ENVIRONMENTAL LAW & POLICY CENTER

Re: Draft Environmental Impact Statement for Combined License (COL) for Enrico Fermi Unit 3, NUREG-2105, Docket No. NRC-2008-0566

The Environmental Law and Policy Center, a Midwest-based not-for-profit environmental quality and economic development organization, and the Michigan Environmental Council, a Michigan not-for-profit environmental organization representing a coalition of over 70 organizations, submit the following comments on the Draft Environmental Impact Statement ("Draft EIS") for Detroit Edison's Combined License ("COL") application.

Figure 1. Karst areas identified in Monroe County, MI (Source: SEMCOG, 2010)

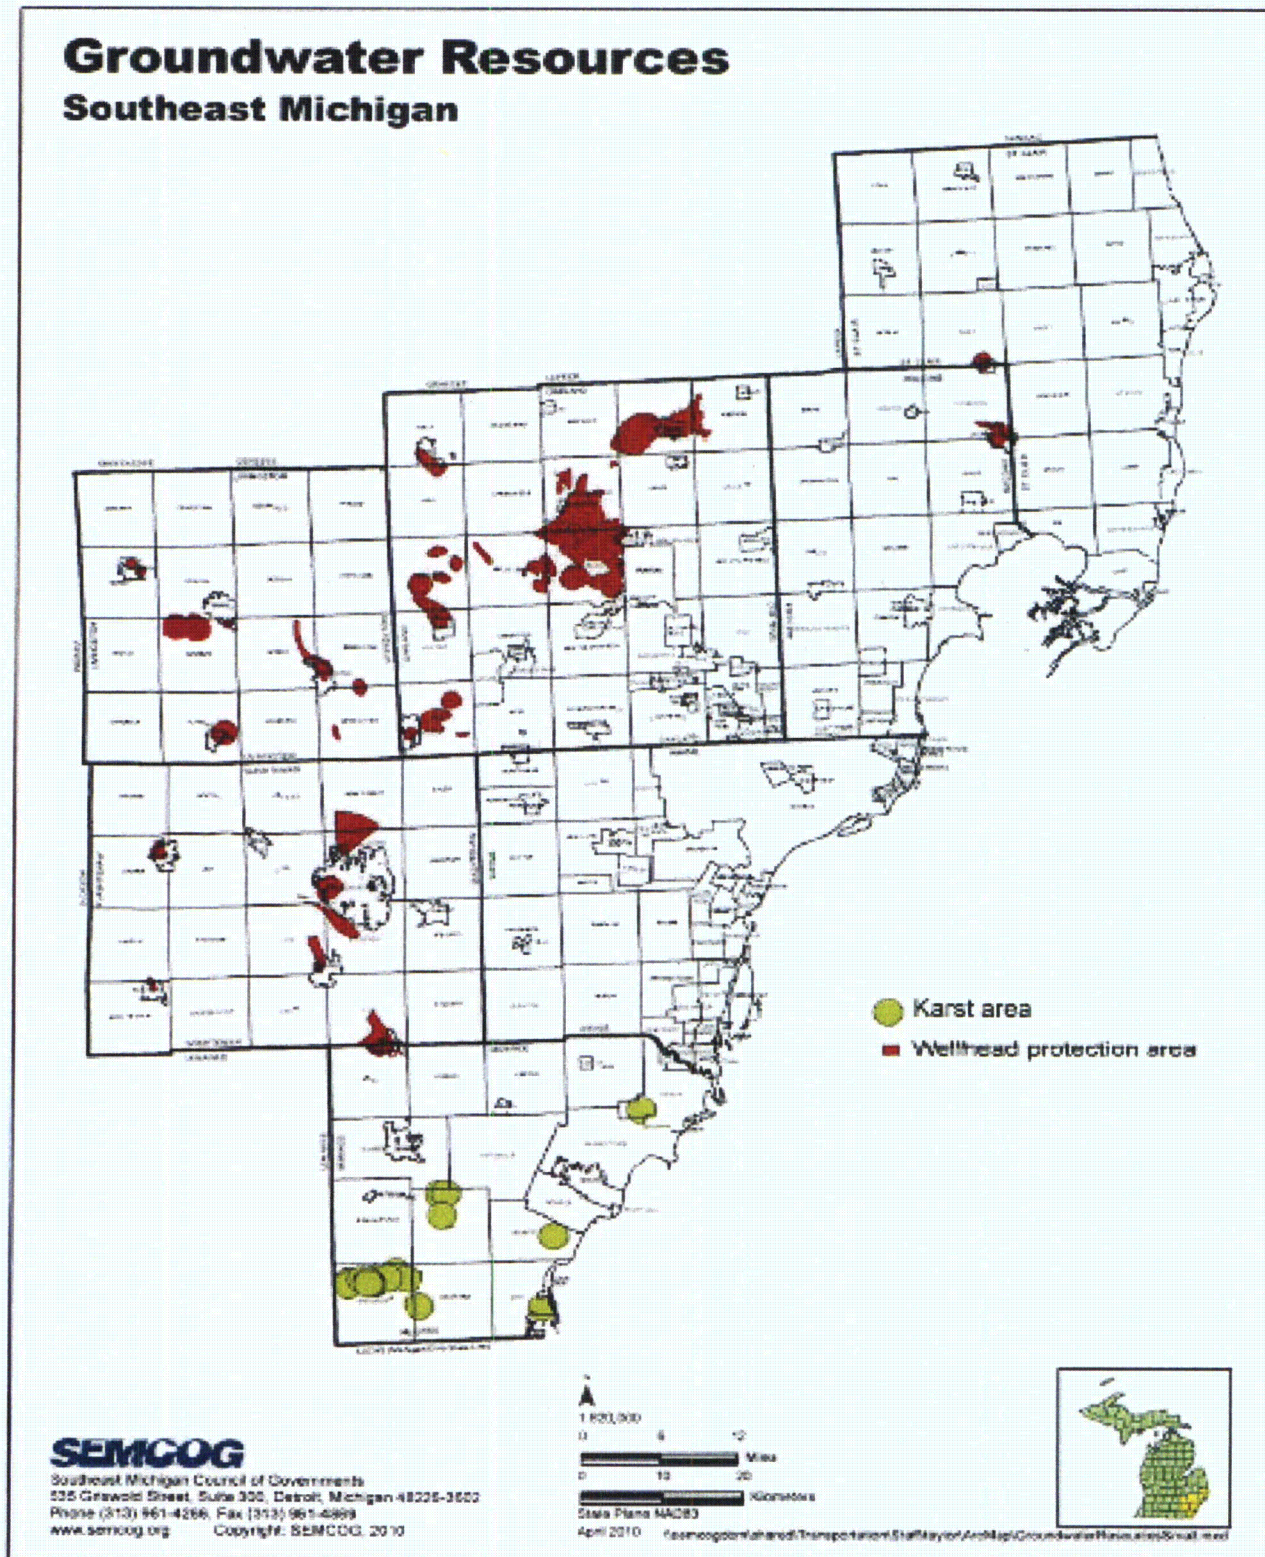
Section 2.5.3.8.2 of the FSAR claims that “the potential for nontectonic deformation at the Fermi 3 site is negligible,” and that “there is no evidence of nontectonic deformation at the Fermi 3 site in the form of unloading phenomenon (i.e., pop-up features), glacially-induced faulting, salt migration, dissolution or collapse related to karst, or volcanic intrusion.” But Figure 1 (below), which identifies several known Karst areas in Monroe County, Michigan where the Fermi site is located, demonstrates that a more thorough search for this type of subsurface formation in the area is warranted. Two concerns related to this issue include:

- Risk of future subsidence at the site that could damage the structural integrity of the reactor containment building, existing or potential radioactive waste storage facilities, and other important structures.
- Risk of contamination of groundwater beyond the Fermi site via unknown flow pathways that are typically inherent in Karst formations even where obvious underground voids are not identified through bore sampling and other techniques.

More evaluation of these risks is necessary to reduce the uncertainty raised by the existence of multiple Karst formations so near to the proposed project site as shown in Figure 1.
